JLRTB02012NAS2

TECHNICAL BULLETIN

'Gearbox Fault Detected' Displayed On The Instrument Panel Cluster (IPC)

MODEL:	MODEL YEAR:	VIN:	ASSEMBLY PLANT:
I-PACE (X590)	2019-2020	F60094-F80069	Graz (Austria)

E256857

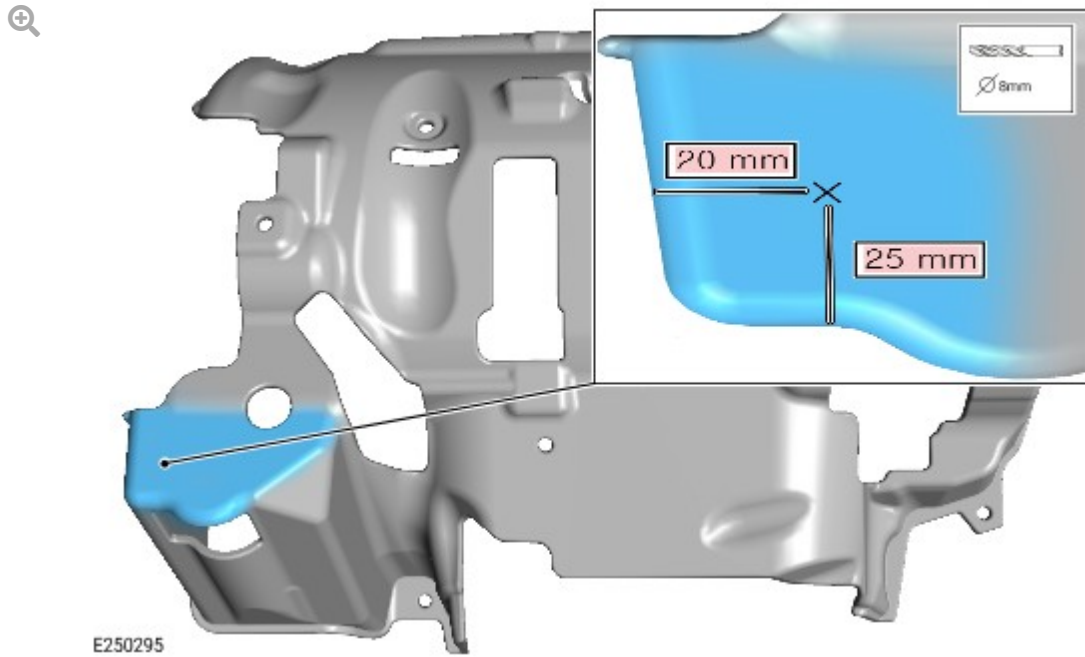
- ■ If the park lock actuator connector (C1YE113A) wiring is found to be damaged, as per the illustration, **continue to step 2**.

-
3. An Electronic Product Quality Report (EPQR) must be submitted to provide a clear photograph of the original damaged wiring harness installed on the vehicle. See step 1 for example photographs.

Renew the front compartment wiring harness (see TOPIx Workshop Manual section 418-02: Wiring Harnesses - Removal and Installation - Front Compartment Wiring Harness).

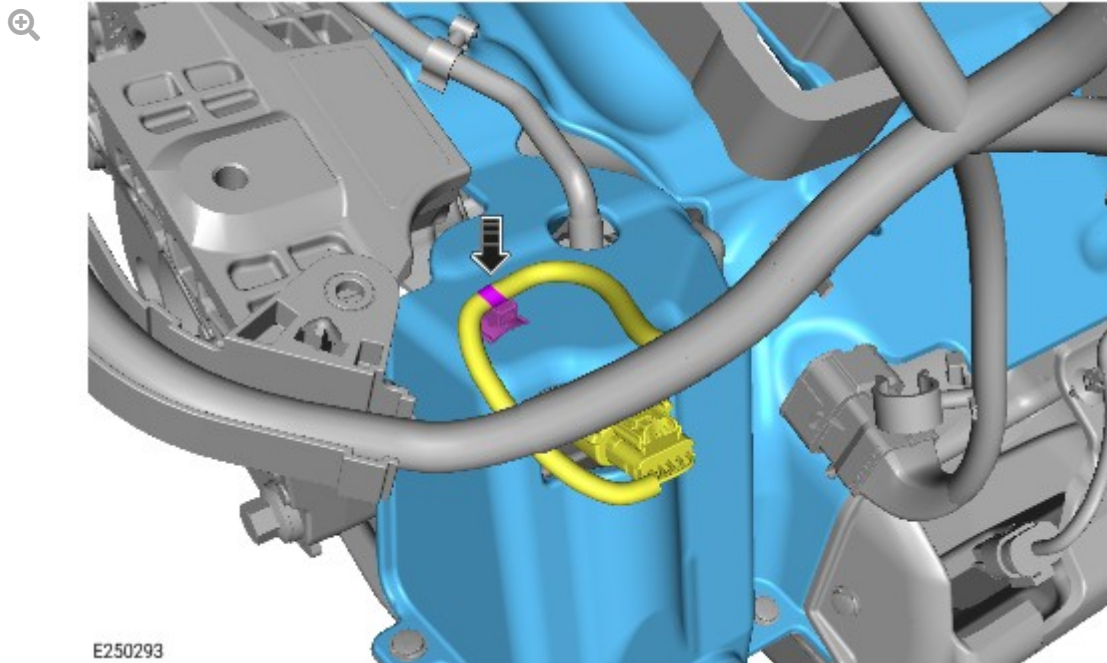
Using a suitable tool, create a hole in the EDU upper Noise, Vibration and Harshness (NVH) cover, as shown in the illustration.

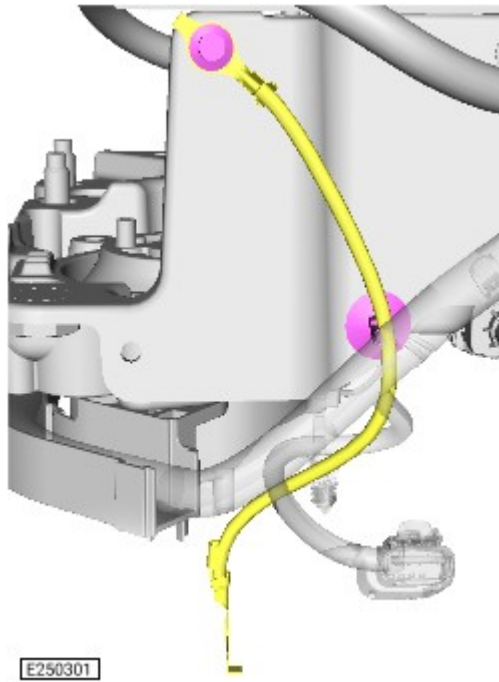
During the installation of the front EDU, make sure the new wiring harness clip is installed in the NVH cover, as shown in the illustration.

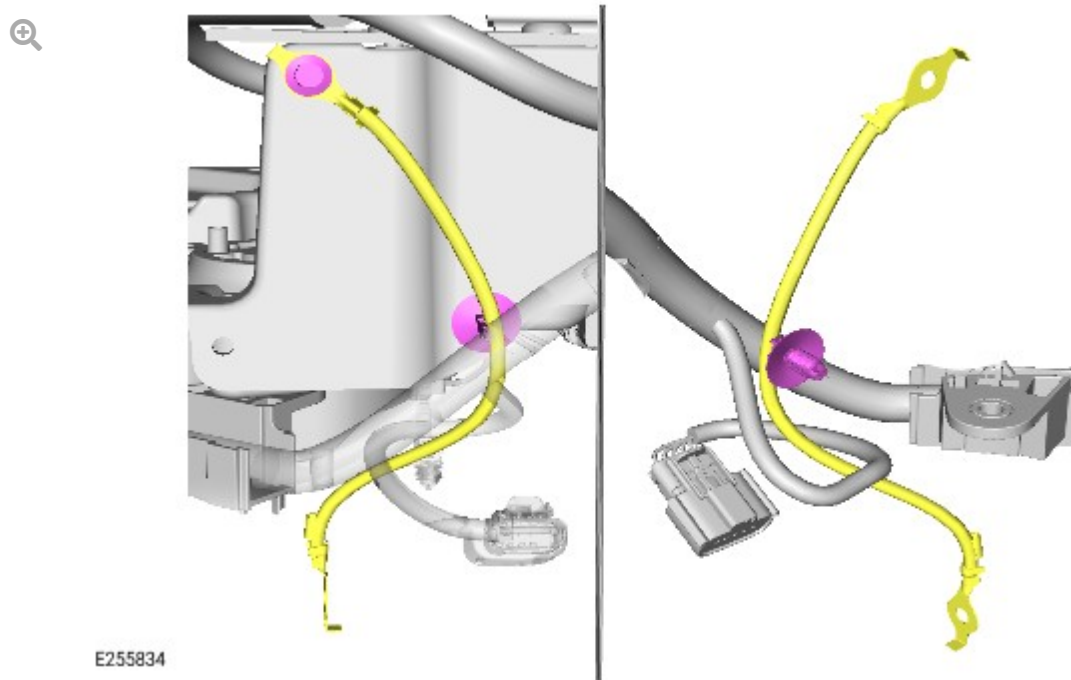
Make sure the new front EDU ground cable is routed through the loop formed by the park lock actuator break out harness, as shown in the illustration.

Install the new front EDU ground cable.

- ■ Secure the ground cable with the retaining clip.
- ■ Tighten the bolt.
 - ■ Torque: **24 Nm**
